dsPIC33EPXXXGS70X/80X Family Silicon Errata and Data Sheet Clarification

The dsPIC33EPXXXGS70X/80X family devices that you have received conform functionally to the current Device Data Sheet (DS70005258C), except for the anomalies described in this document.

The following typographic corrections and clarifications are to be noted for the latest version of the device data sheet (DS70005258C):

FIGURE 1:

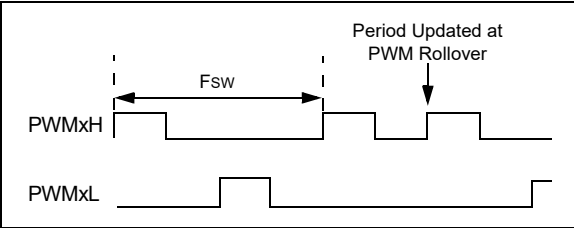
When the PWM module is configured for Push-Pull mode (IOCONx[11:10] = 0b10) with the Enable Immediate Period Update bit enabled (PTCON [10] = 1), a write to the Period register that coincides with the period rollover event may cause the push-pull output logic to produce back-to-back pulses on the PWMx pins (see Figure 1).

Ensure that the update to the PWM Period register occurs away from the PWM rollover event by setting the EIPU bit (PTCON[10] = 1). Use either the PWM Special Event Trigger (SEVTCMP) or the PWM Primary Trigger (TRIGx) to generate a PWM Interrupt Service Routine (ISR) near the start of the PWM cycle. This ISR will ensure that period writes do not occur near the PWM period rollover event.

FIGURE 2: EXAMPLE FOR REDUNDANT OUTPUT MODE

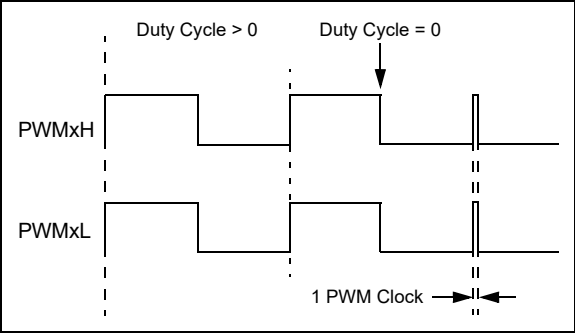
In the Redundant Output mode (IOCONx[11:10] = 0b01) and Push-Pull Output mode (IOCONx[11:10] = 0b10), with the Immediate Update Enable bit disabled (PWMCONx[0] = 0), when the Duty Cycle register is updated from a non-zero value to zero, a glitch pulse of a width equal to 1 PWM clock will appear at the next PWM period boundary, as shown in Figure 2 (for the Redundant Output mode). The Duty Cycle register refers to the PDCx register if PWMCONx[8] = 0 or the MDC register if PWMCONx[8] = 1.

If the application requires a zero duty cycle output, there are two possible work around methods:

1. Use the PWM override feature to override the PWM output to a low state instead of writing to the Duty Cycle register. In order to switch back to a non-zero duty cycle output, turn off the PWM override. The override-on and override-off events must be timed close to the PWM period boundary if the IOCONx register has been configured with IOCONx[0] = 0 (i.e., output overrides through the OVRDAT[1:0] bits occur on the next CPU clock boundary).
2. Enable the Immediate Update Enable bit (PWMCONx[0] = 1) while configuring the PWMx module (i.e., before enabling the PWMx module, PTCON[15] = 1). With the Immediate Update enabled, writes to the Duty Cycle register can have an immediate effect on the PWM output. Therefore, the duty cycle write operations must be timed close to the PWM period boundary in order to avoid distortions in the PWM output.

FIGURE 3: SIMPLIFIED BEHAVIOR

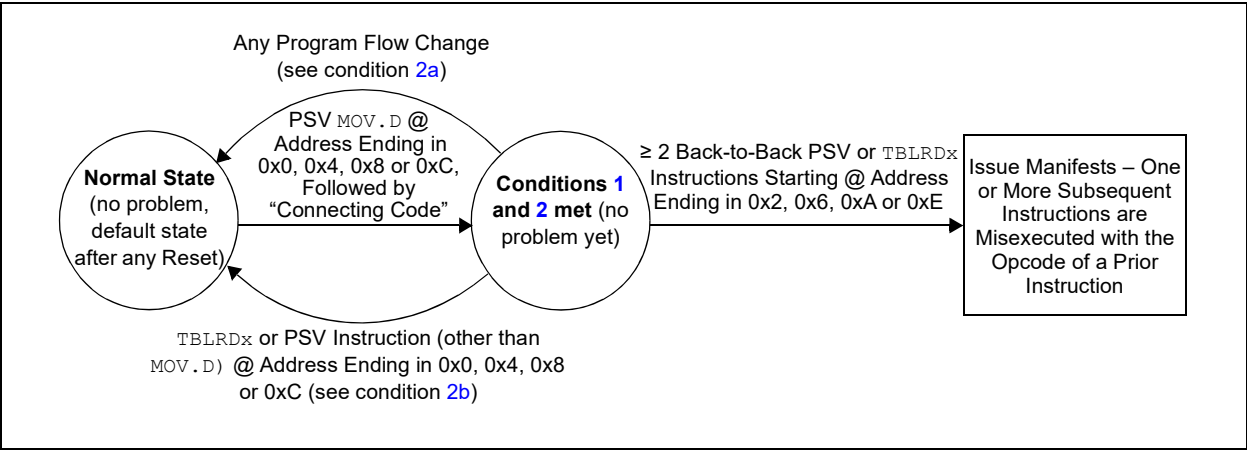
When two or more data Flash read instructions (via Program Space Visibility (PSV) read or Table Read) are executed back-to-back, one or more subsequent instructions can be misexecuted when all of the conditions in Table 4 occur.

Figure 3 provides an example of the effective behavior.

The issue can be avoided by ensuring any one or more of the requirements are not met. For example:

1. All instances of PSV MOV.D can be replaced with two PSV MOV instructions instead. Non-PSV MOV.D instructions acting on RAM/SFRs do not need to be modified; or
2. If not already present, a program flow change instruction (such as BRA \$+2) can be inserted above back-to-back data Flash read sequences; or
3. Back-to-back data Flash read instruction sequences can be broken up by inserting a non-Flash read instruction (such as a NOP), in between the Flash read instructions; or
4. The alignment of the code can be shifted to avoid the required opcode location addresses.

FIGURE 4-2: PROGRAM MEMORY MAP FOR dsPIC33EP128GS70X/80X DEVICES

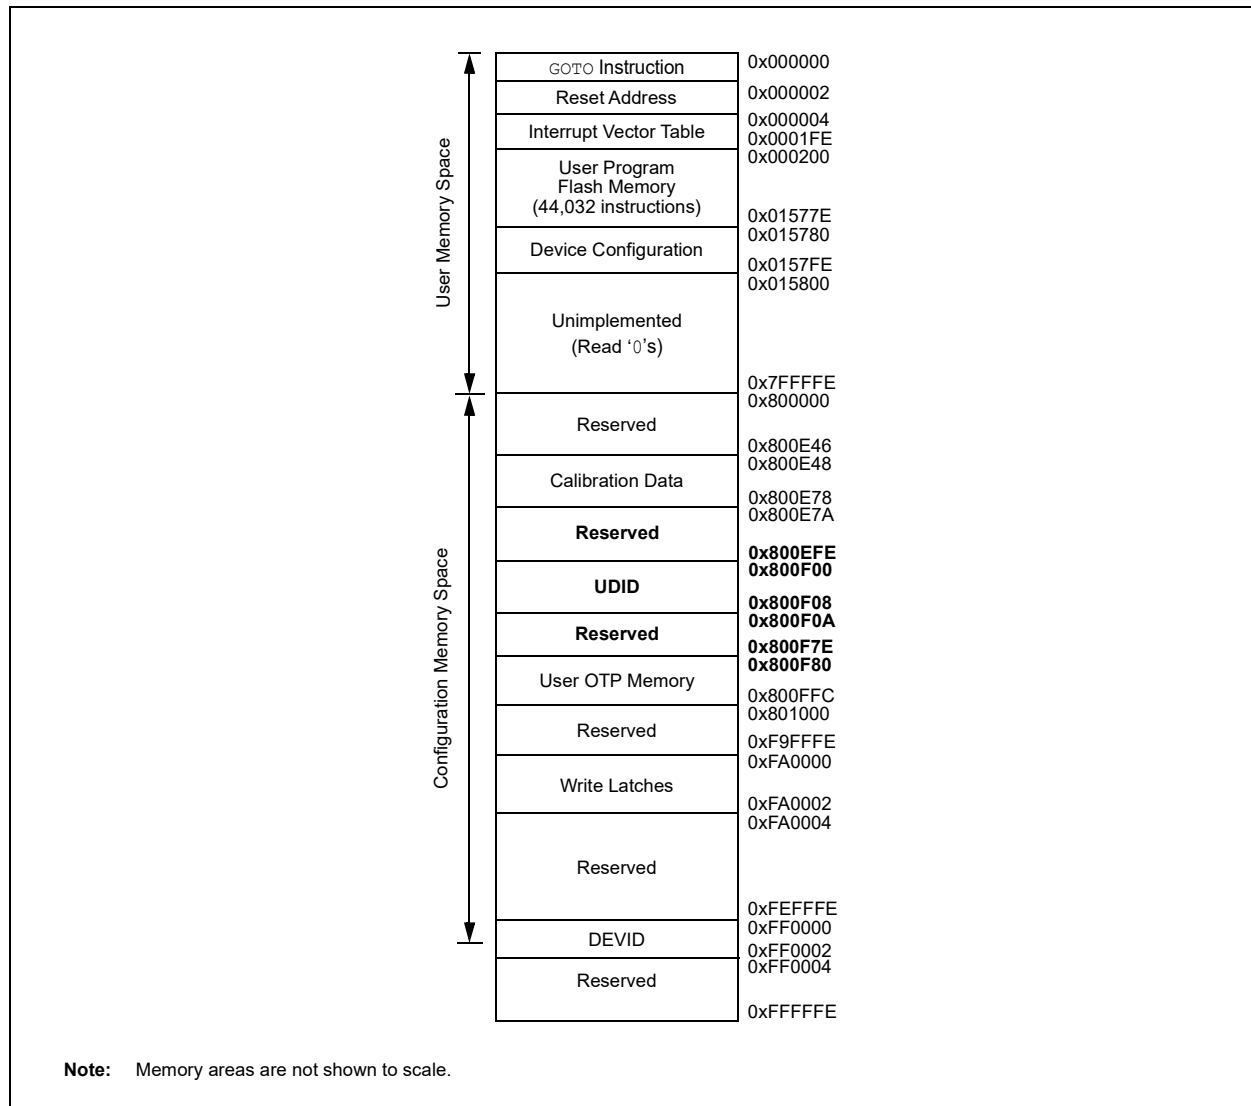
In [Figure 4-2](#), the following changes have been made as shown in **bold**:
